SUNDRY NOTICES AND REPORTS ON WELLS

PROPOSED PLUG & ABANDONMENT

Well Name: Corrienta 12 Federal #1		Field: West Corbin	
Location: Se. 12, T18S, R32E, 860' FSL, 1980' FWL		County: Lea	State: NM
Elevation: GL- 3850', KB- 3867'		Spud Date: 4/30/1990	Compl Date: 7/7/1990
API#: 30-025-30859	Prepared by: Seyi Harris	Date: 02/05/05	Rev:

RE: Plugging and Abandonment Requirements, Conditions of Approval

☒ PROPOSED ☐ CURRENT

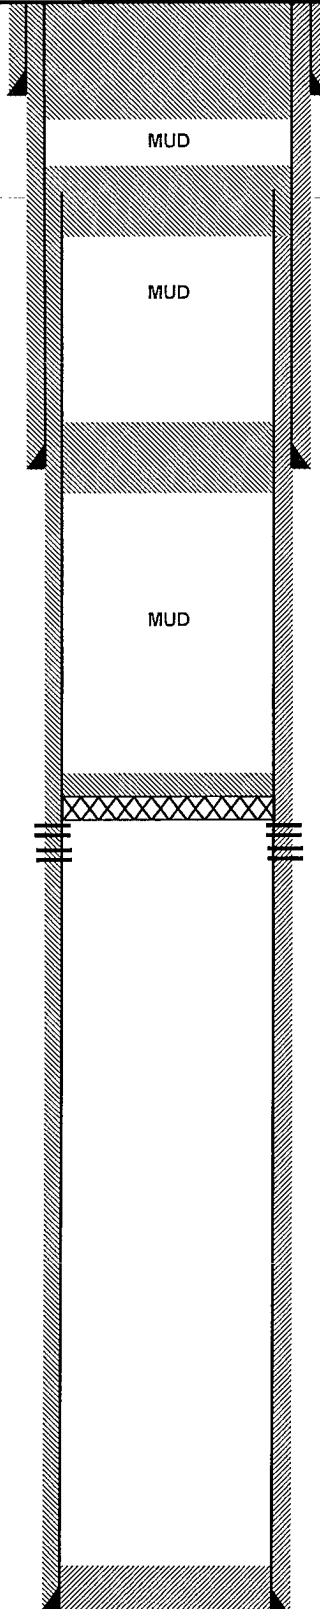
1. OK
- 1a. Spot plug (minimum 25sx) from 6725'-6555'. (Bone Spring)
2. Change: Set CIBP at 4916'. Spot 25sx on top of CIBP (Perfs – Delaware)
3. OK
4. WOC and tag at 2650' or shallower – Otherwise OK (Casing shoe – Yates – BOS)
5. OK
6. If cut is above 1200', changes may be made – Otherwise OK (TOS – Stub)
7. OK (Casing shoe – Surface)
8. Verify that all annuluses have cement to surface and fill in as required. Ground level dry hole marker to be set in this area; Requirements attached – Otherwise OK
9. Submit a subsequent report to the BLM.
